# ENCORE APARTMENTS

DPD # 3020094  
2ND DESIGN RECOMMENDATION  
20 DECEMBER 2016

**PROJECT ADDRESS:**  
3010 1st Ave.

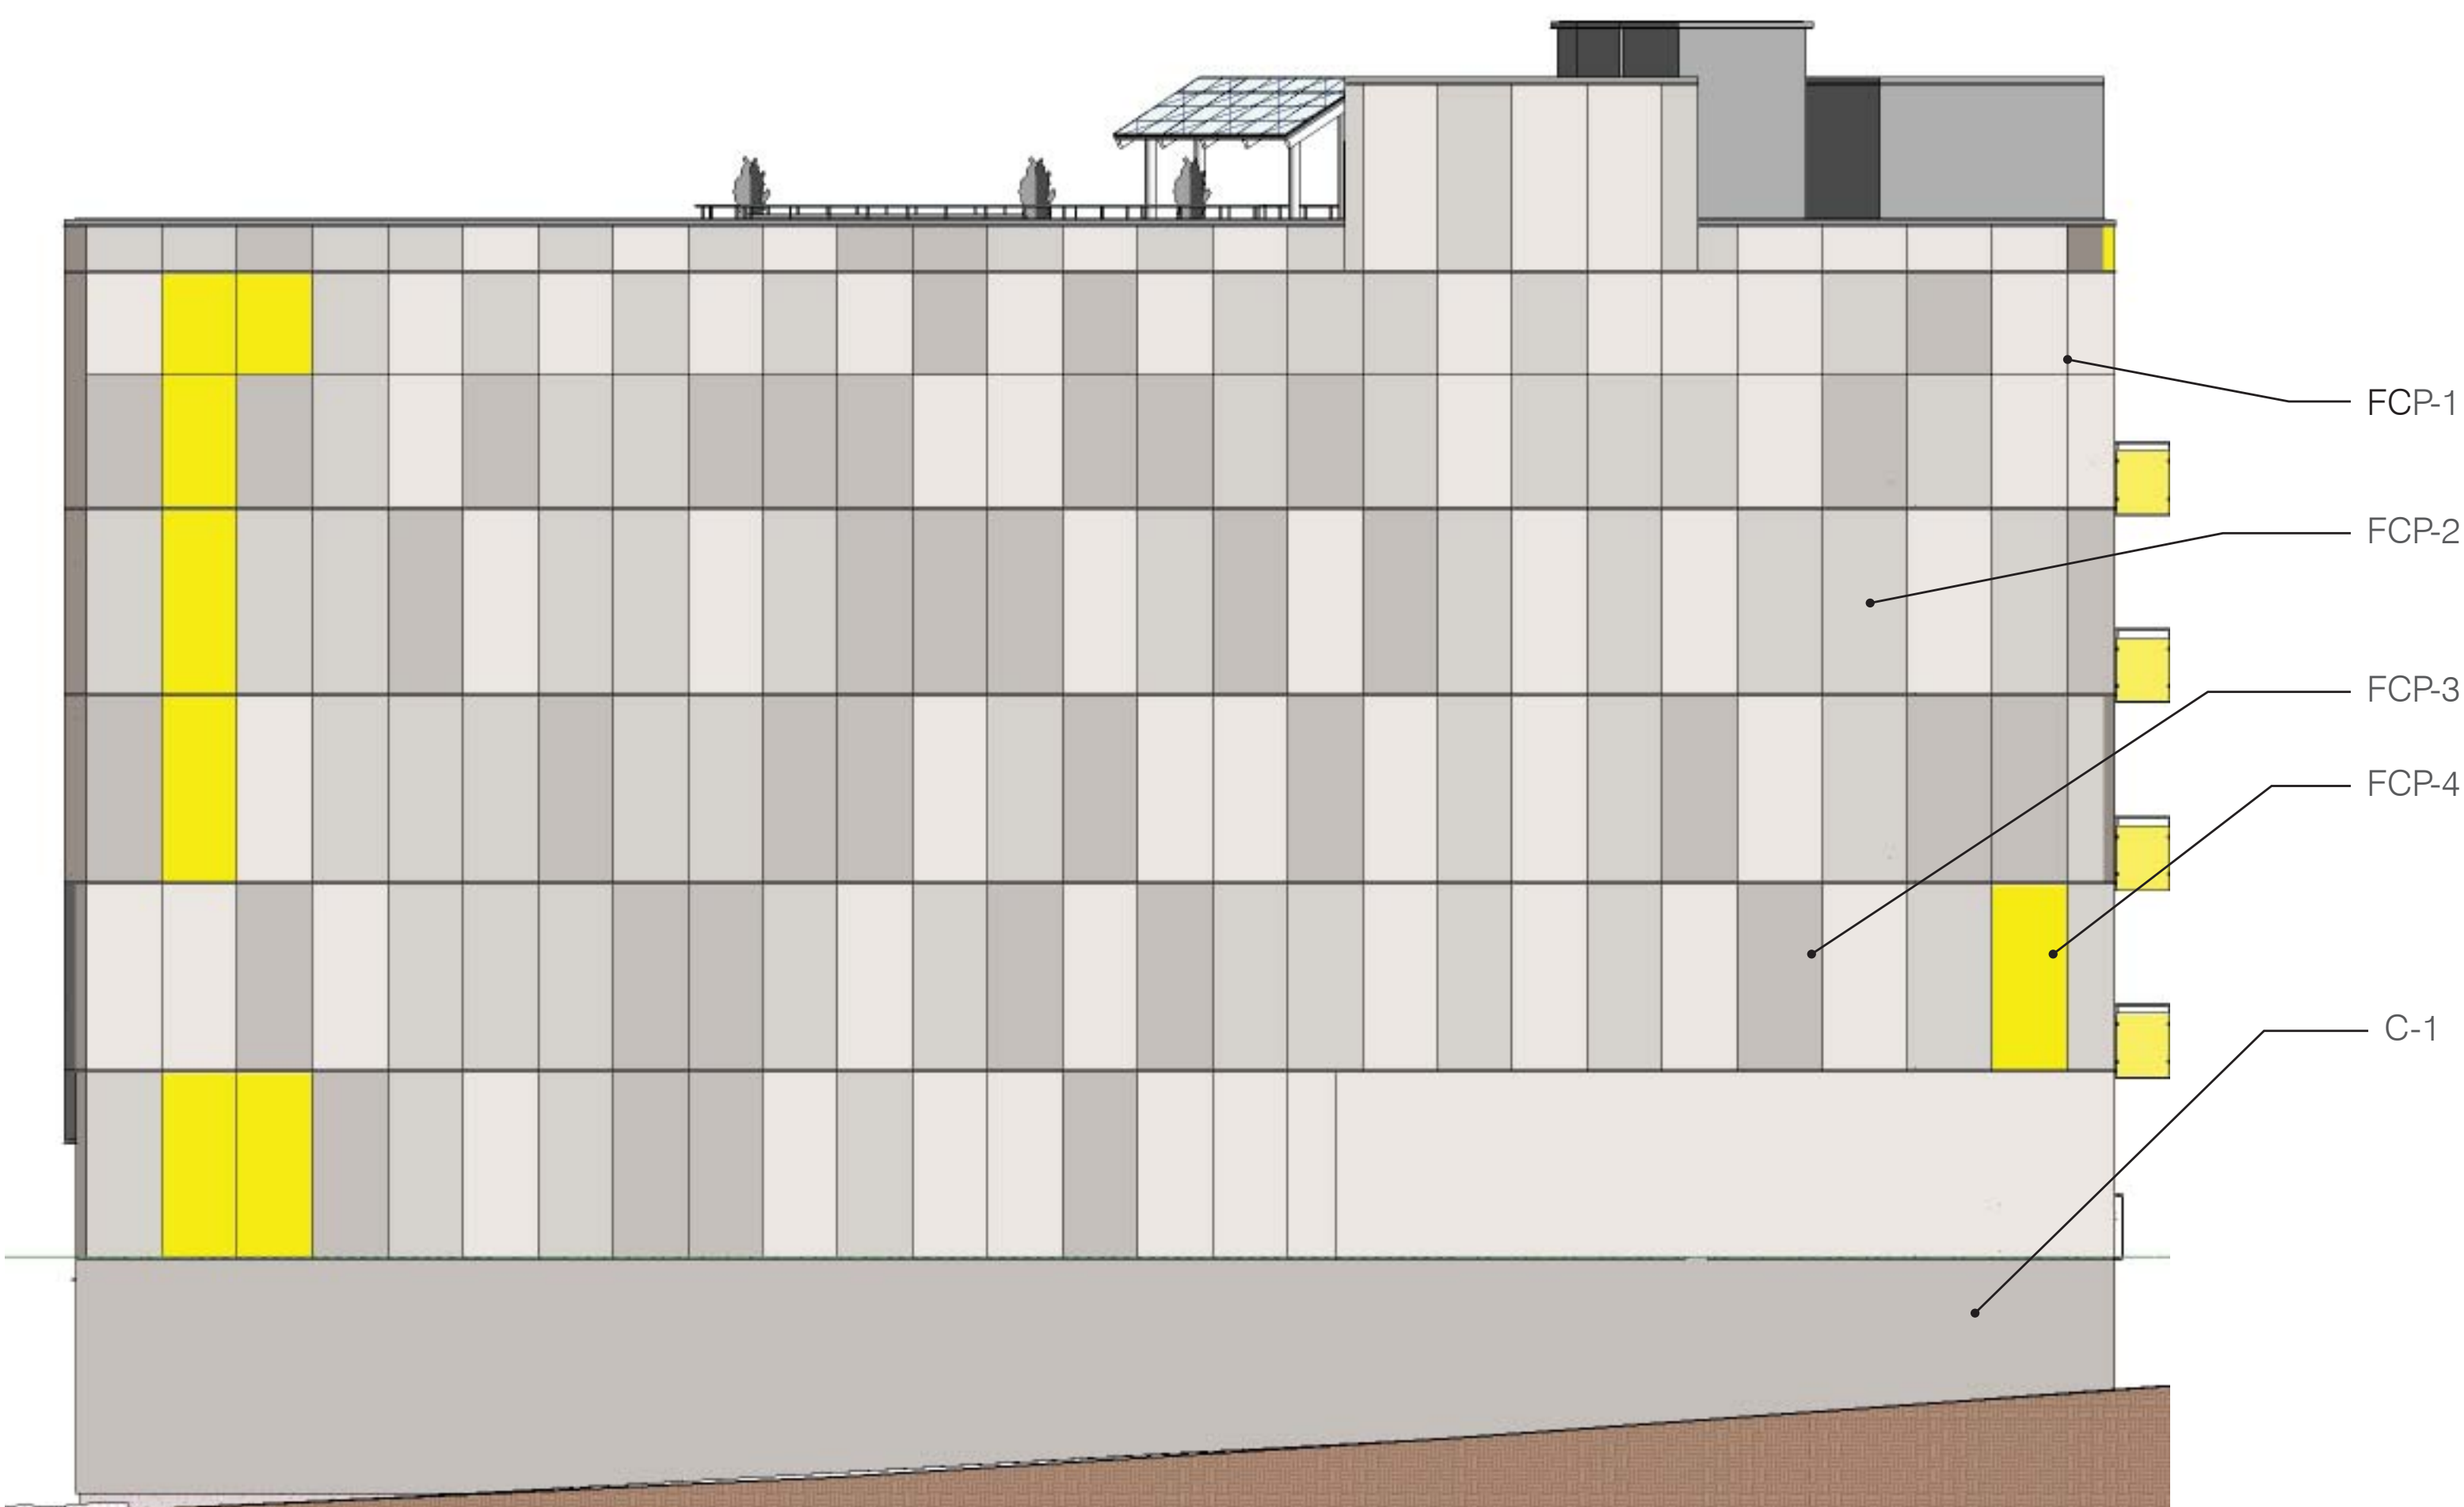
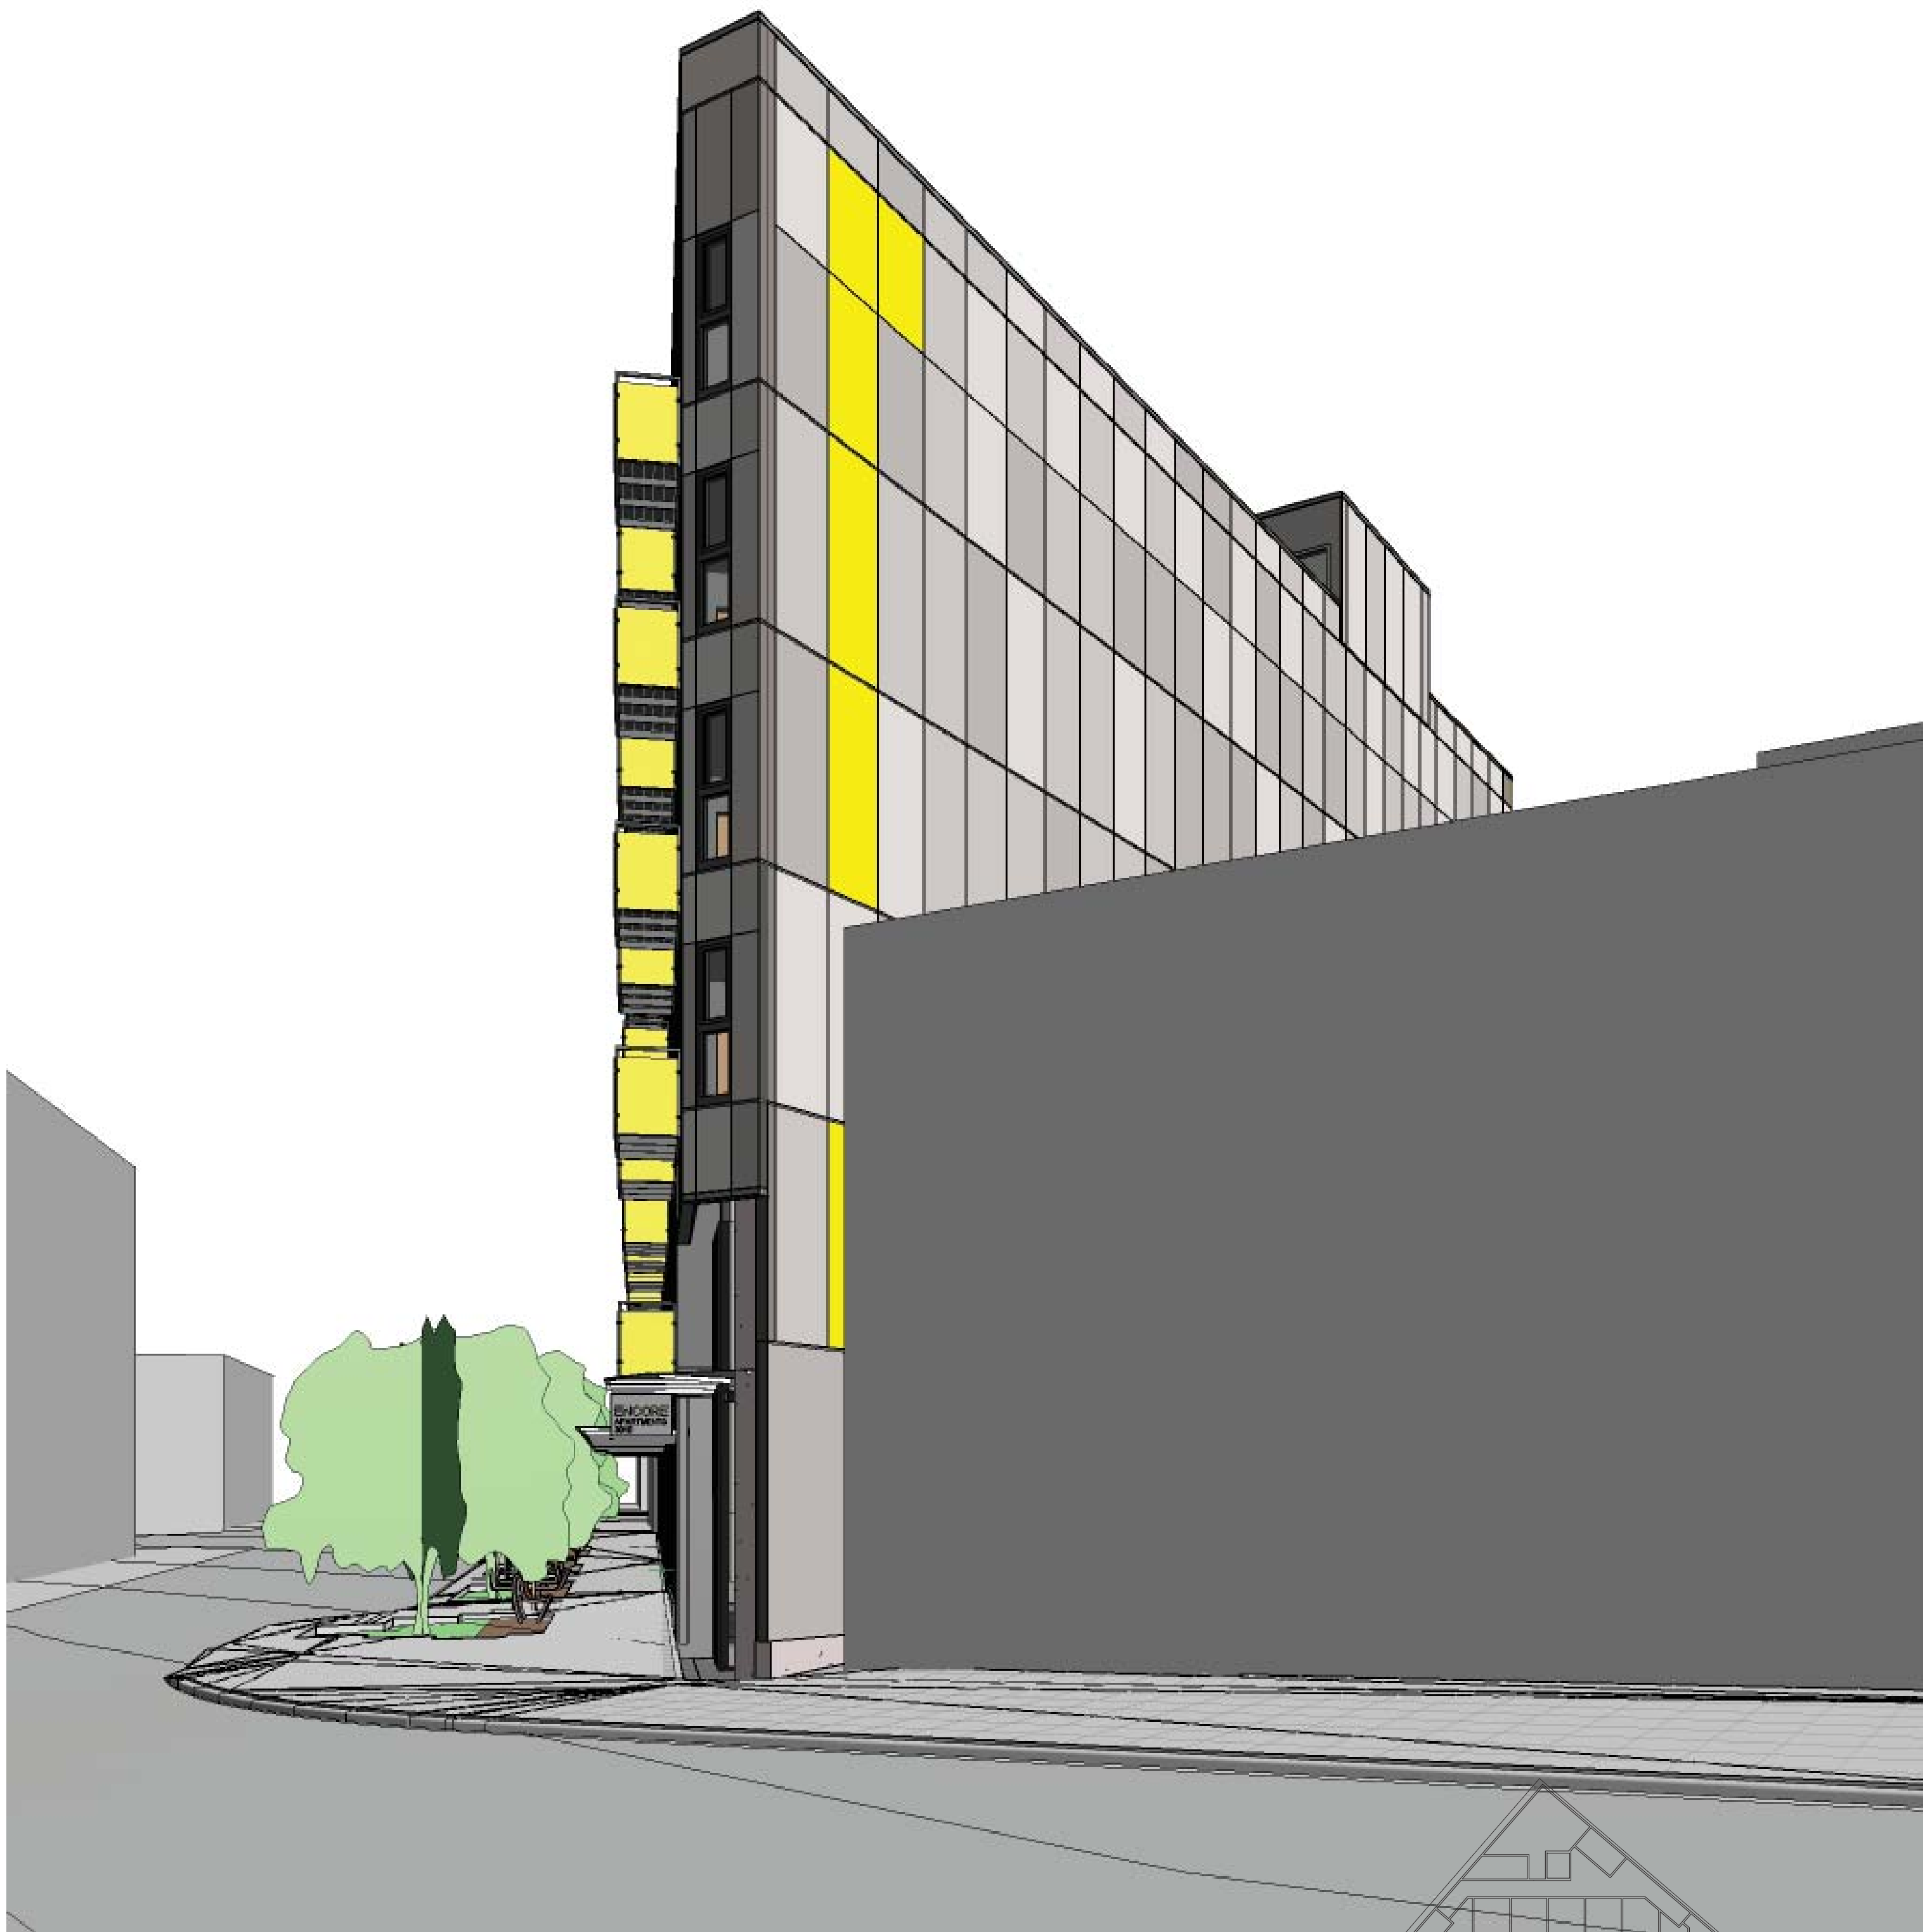
“...The Board agreed that the banding of color appears to take away from the wholeness of taut skin expression. The board recognized that the unique shape of the site warrants a quirky response...The Board strongly recommended more investigation of color, including considering a true pixelated gradation as opposed to the striated gradient shown (B4.2, B4.3)”

Achieving a pixelated gradient with fiber cement panels involves, by necessity, a lot of horizontal and vertical joints. Because of the shift in adjacent colors, the joints would be painted one color; i.e, black. The more joints, and the smaller the fiber cement panels, the more difficult it will be to align them. This scheme is overly busy and will be “dated” after a while. Initial painting and maintenance of the fiber cement panels will be difficult.
